ROCKETDYNE

SPECIFICATION CHANGE INDEX

Specification No. R-3953S

1. FOR ECP NO. NA-MA5-102RL	2. NOMENCLATURE AND MODEL Rocketdyne Liquid-Propellant Rocket Engine Model YLR101-NA-15 (Vernier)	3. SPECIFICATION NO. R-3953S
4. CONTRACT L/C AF04 (695)-500	5. CONTRACTUAL AUTHORIZATION CCN6 (N500-SSD65MSN-53)	FILE OPPOSITE SPEC. PAGE NO. <u>1/1</u>
6. PRODUCTION EFFECTIVITY: <u>NA336589 and subsequent.</u>

FIGURE 1
ESTIMATED NOMINAL ALTITUDE PERFORMANCE
YLR-101-NA-15 MD 2

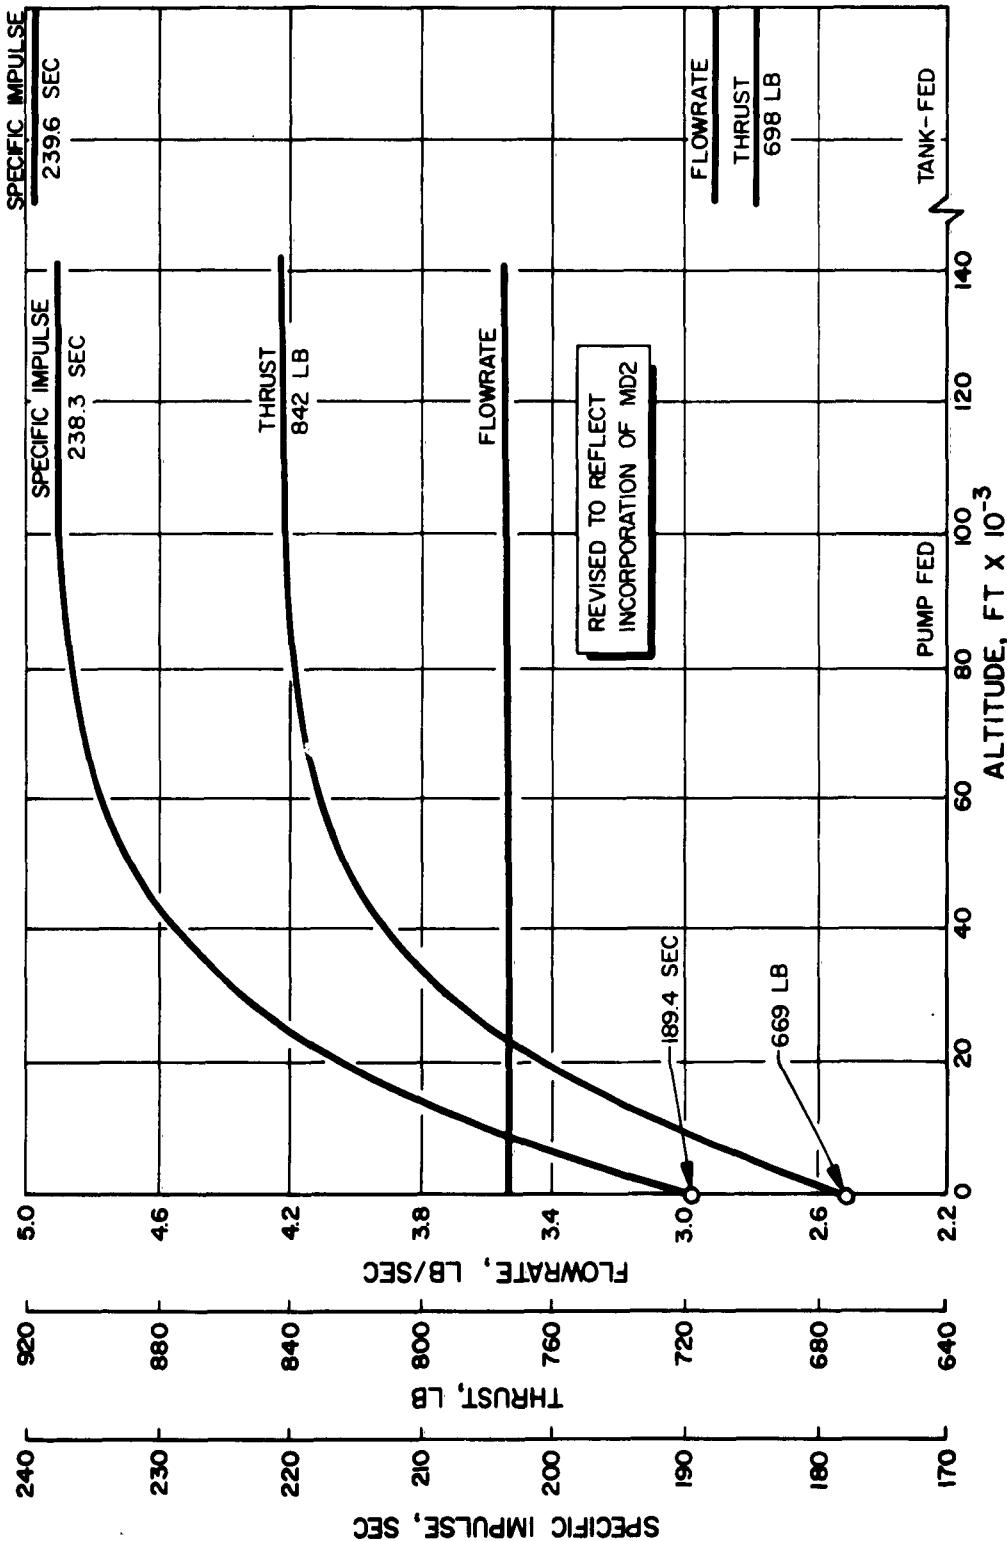
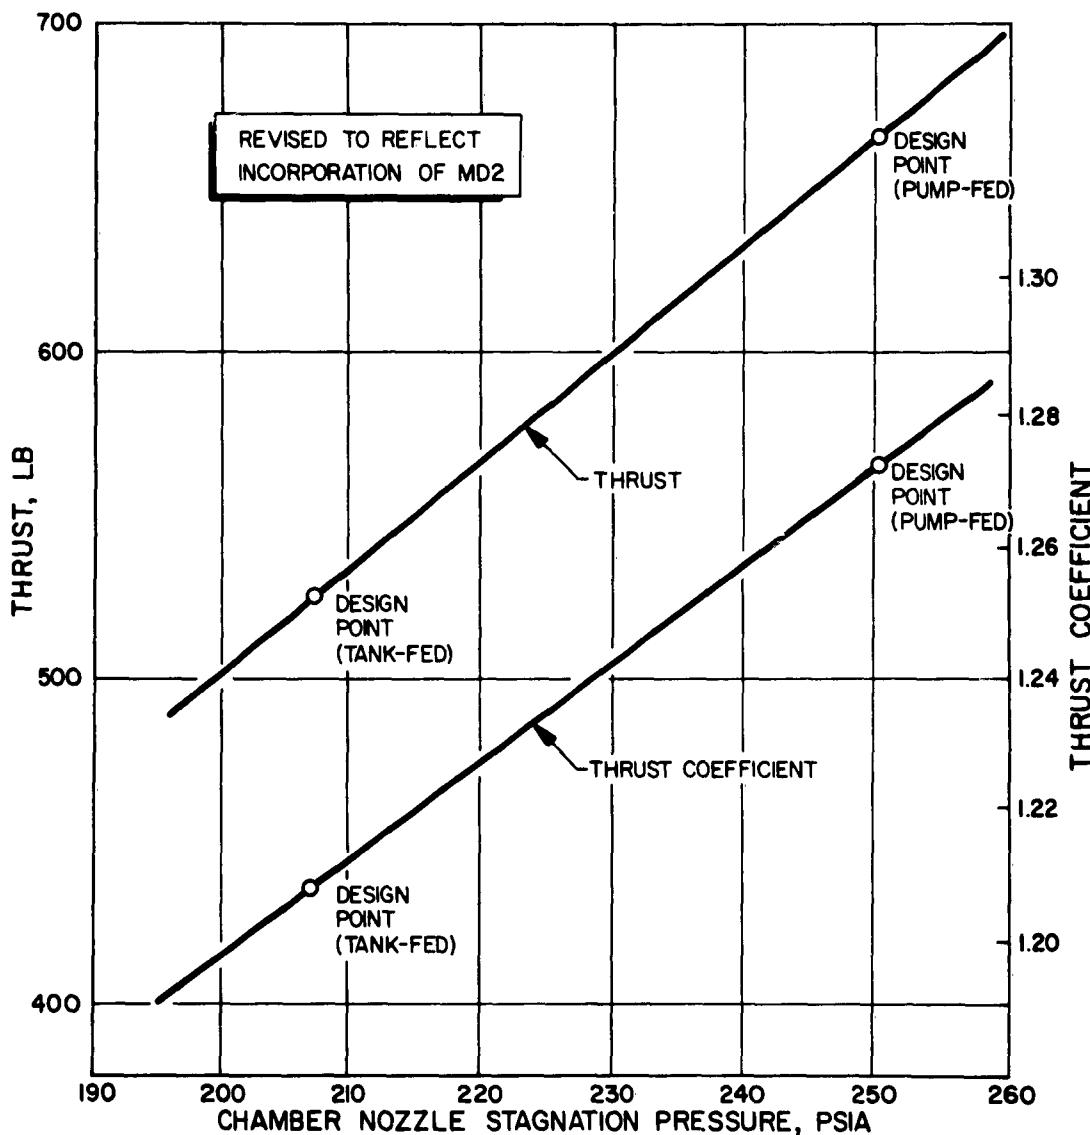
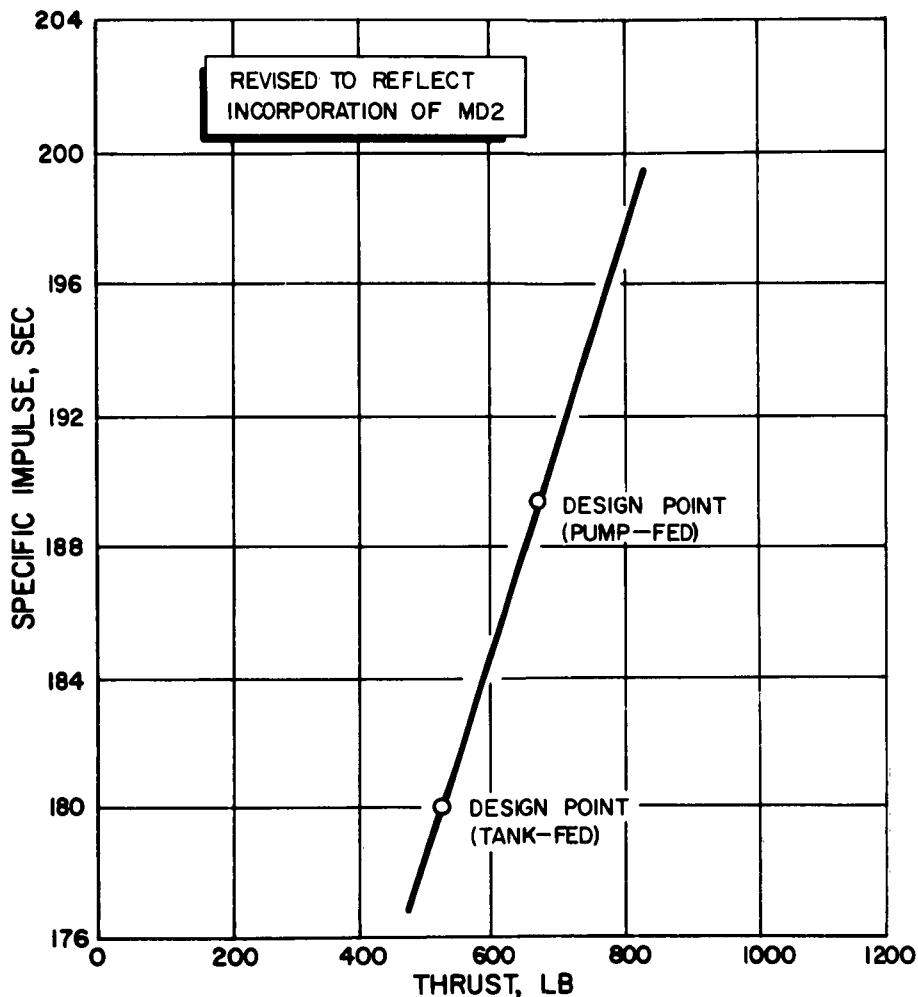
Replace Figure 1, 2 and 4 with Figures 1, 2, and 4 revised* to reflect incorporation of MD2, made a part hereof as Attachments I through III

Page 68	Figure 1	Attachment I
69	2	II
71	4	III

FIGURE 1
ESTIMATED NOMINAL ALTITUDE PERFORMANCE
YLR-101-NA-15 MD I

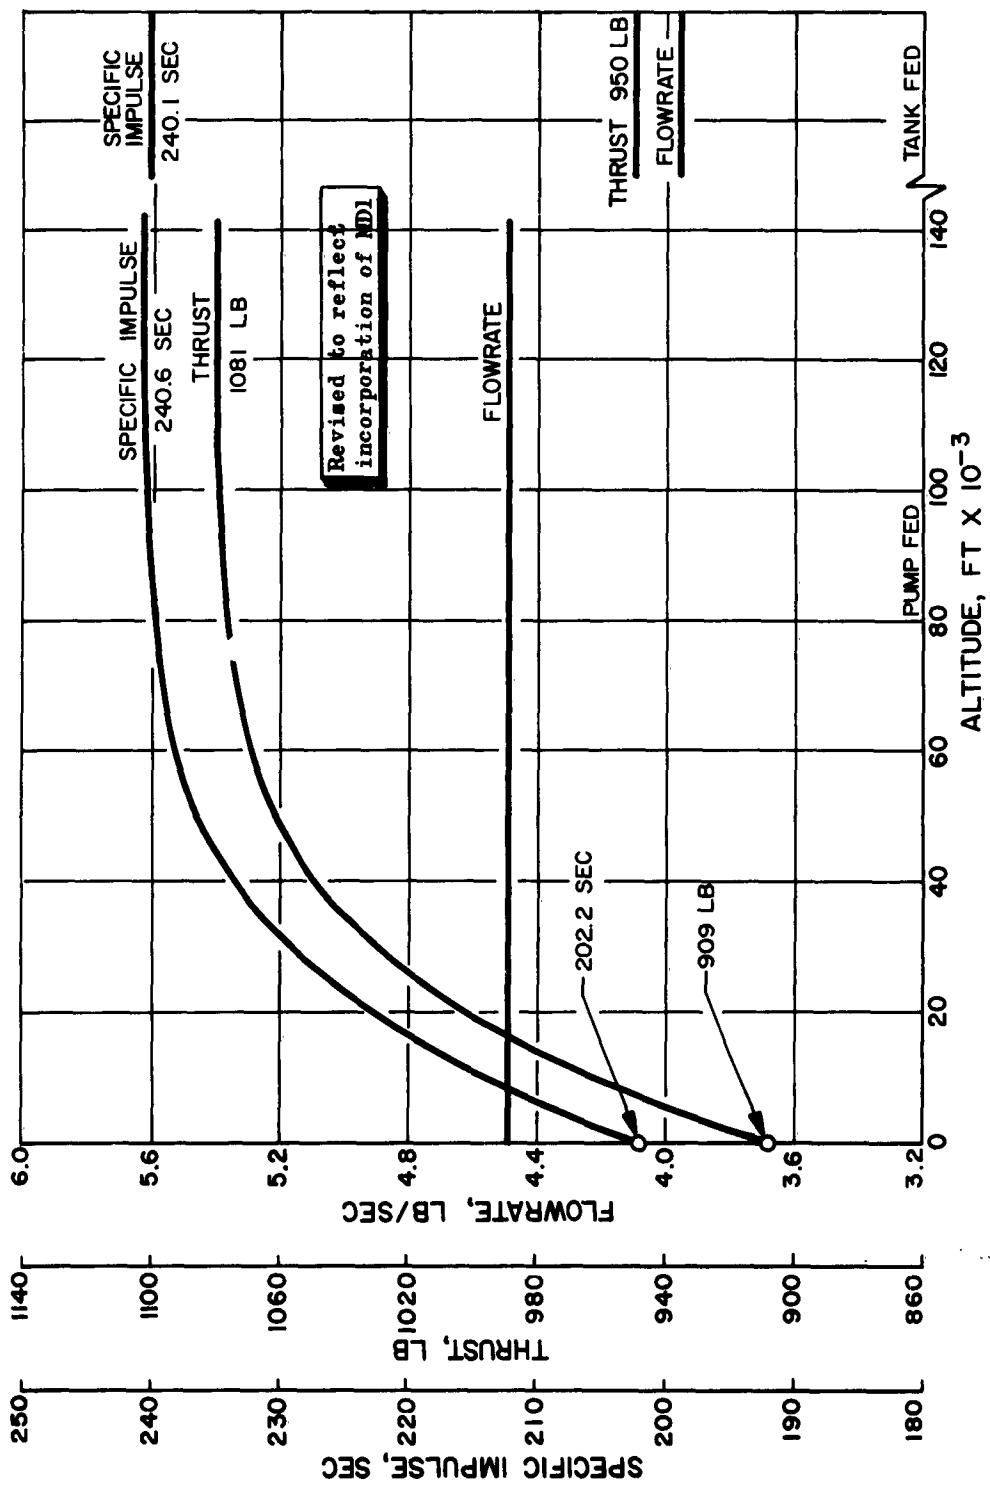
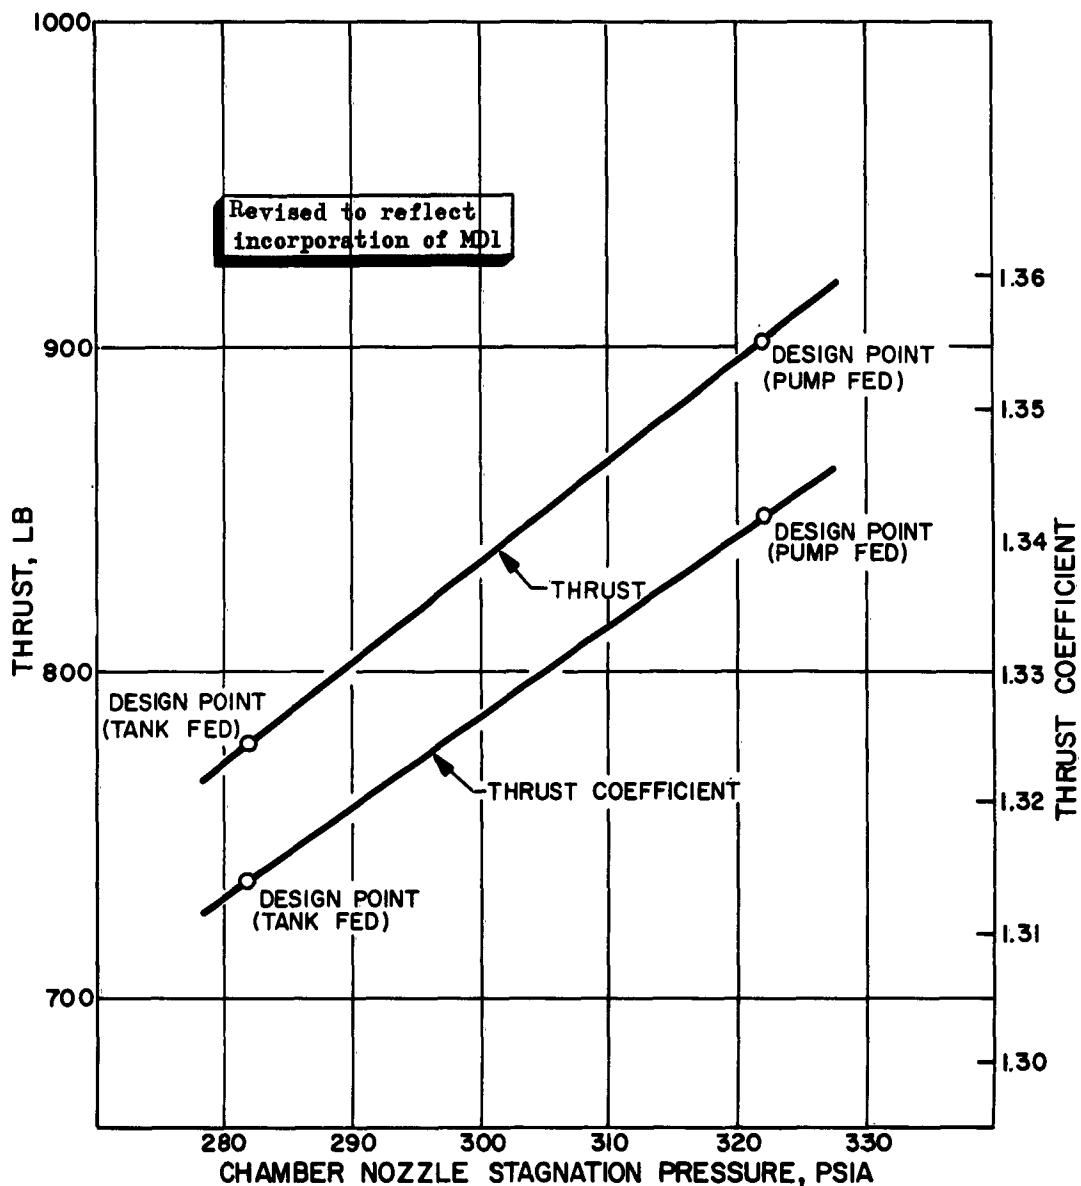
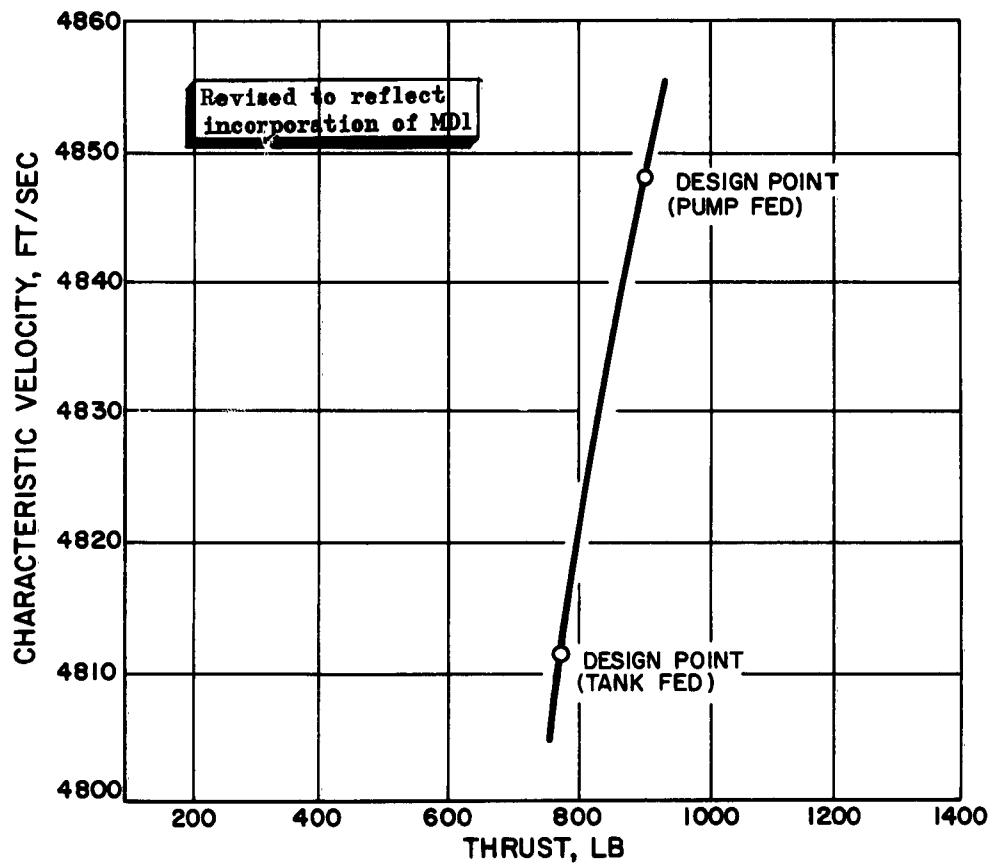
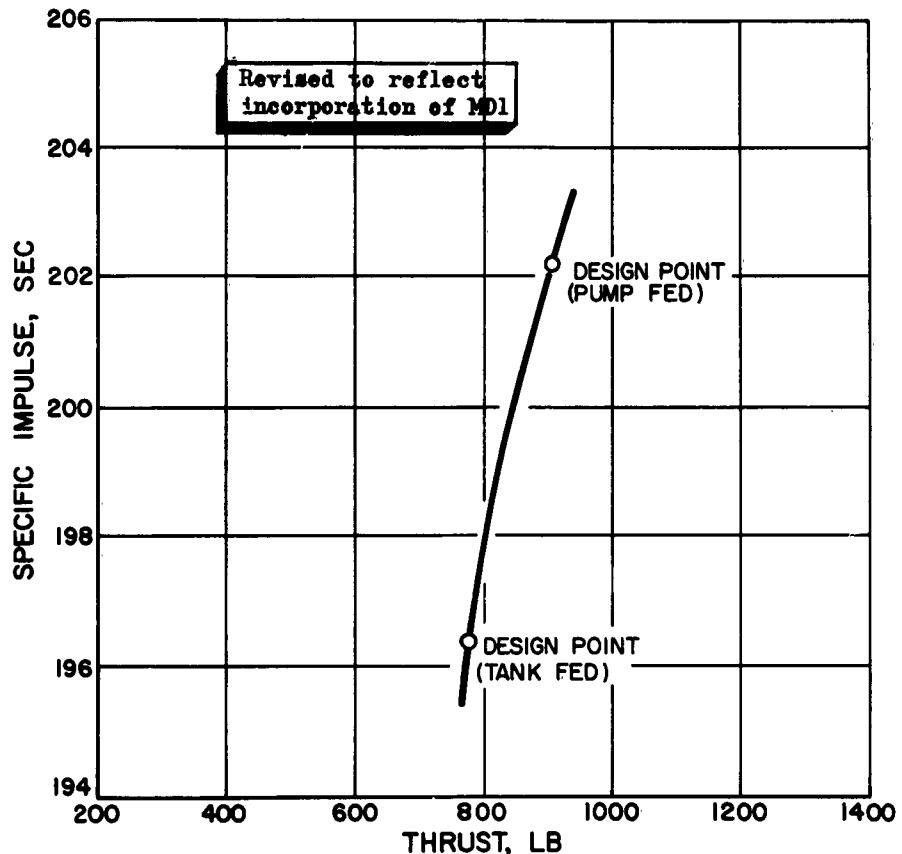
Replace Figures 1 through 4 with Figures 1 through 4 revised* to reflect incorporation of MDI, made a part hereof as Attachments I through IV.

Page 68	Figure 1	Attachment I
69	2	II
70	3	III
71	4	IV
